Figure 2.1g
Infrastructure Design Review
- Turbine 07

Engineering

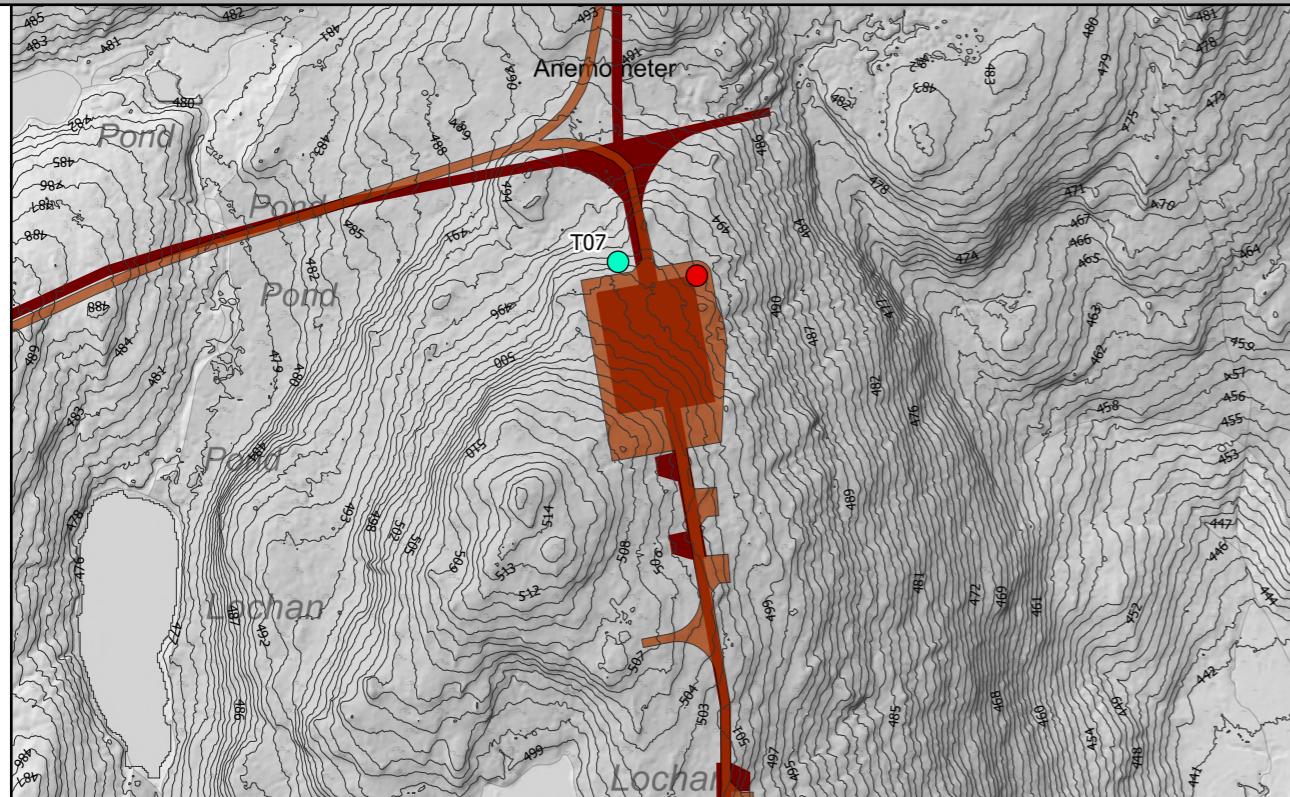
T07: Reason for Moving: Due to the optimization of turbine location T02 and increased rotor diameters, T07 has been moved south to maintain a distance of three rotor diameters from the nearest turbine.

Engineering: The position of the hardstand has not significantly changed, and still attempts to follow the ridgeline as closely as possible to minimise cut-fill requirements. The turning head has been moved to avoid steep reverse driving of unloaded component vehicles.

Geology

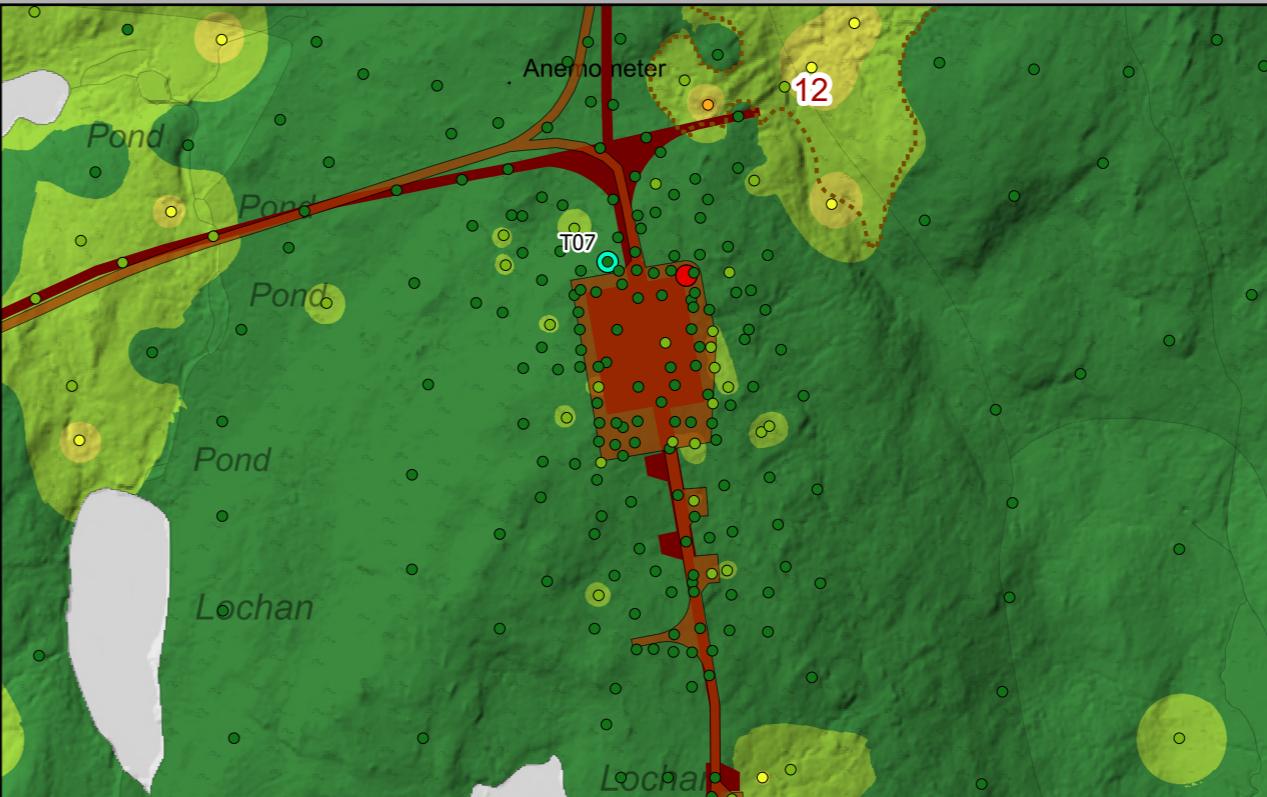
Geology Impacts: The turbine was relocated to the opposite side of the track from its current consented position. The new location is within the 50m micrositing limit from the current consented position, accommodating the required hardstand design for the turbines being considered. All infrastructure remains within the consented 50m micrositing buffer. The turning head has been moved from the end of the spur to a flatter area of land between T07 and T08, and will be used for both locations.

Ecology

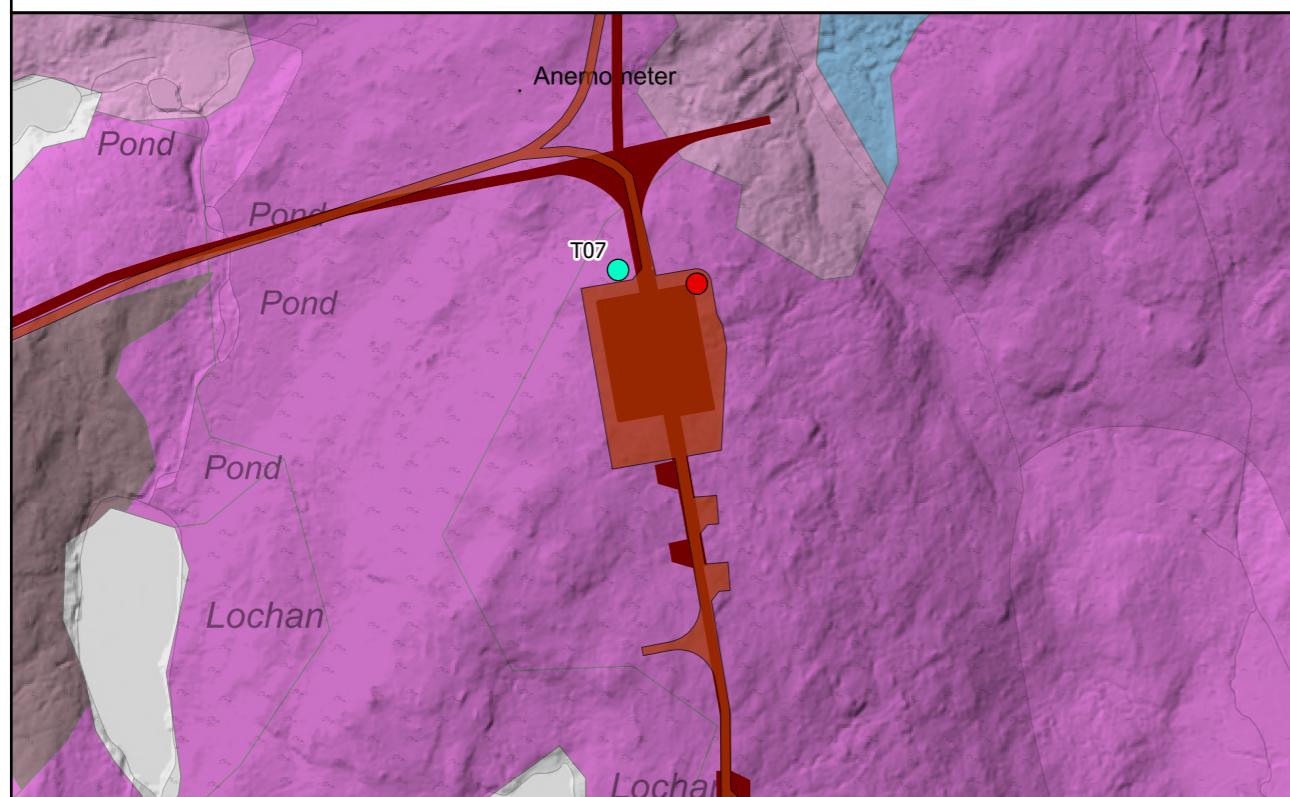
Ecology Impacts: As with the current consented infrastructure, the new layout is entirely within Wet Heath (M15c).

Hydrology

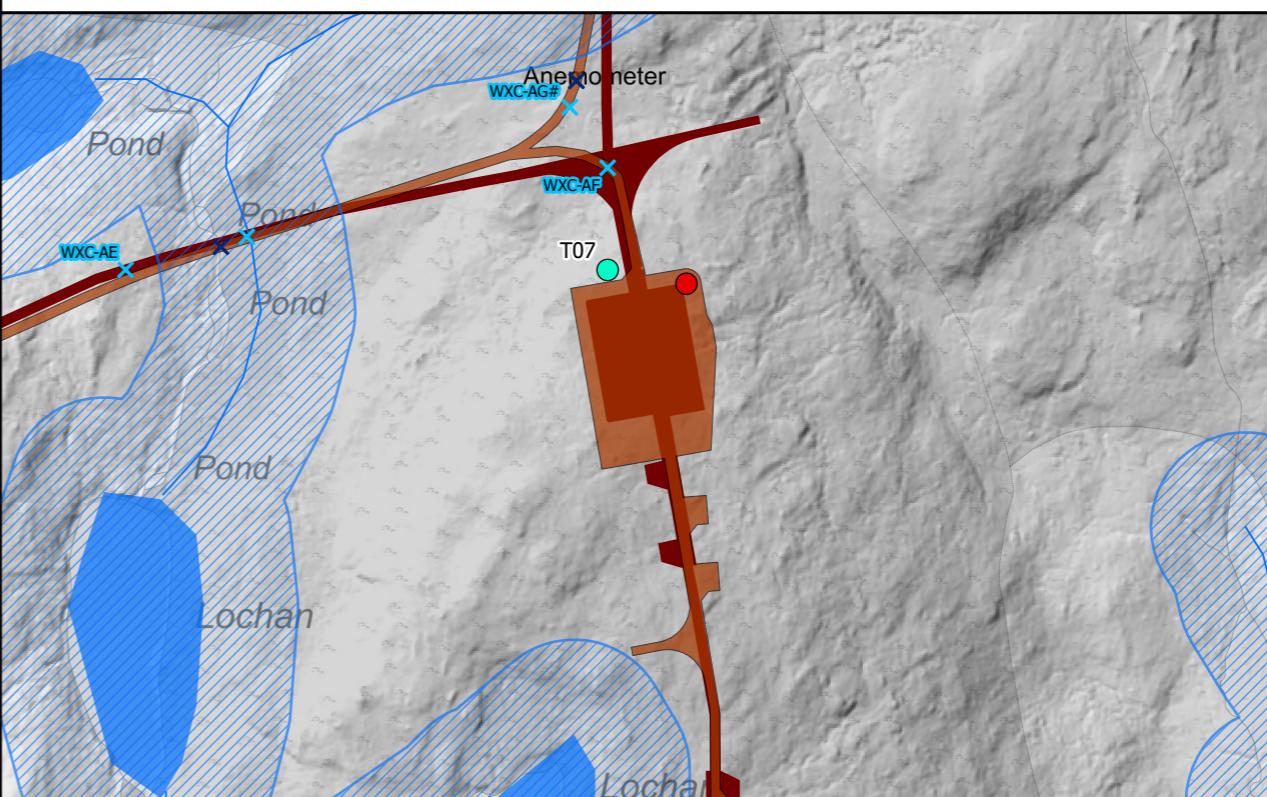
Hydrology Impacts: The proposed location is outside the 50m water buffers.
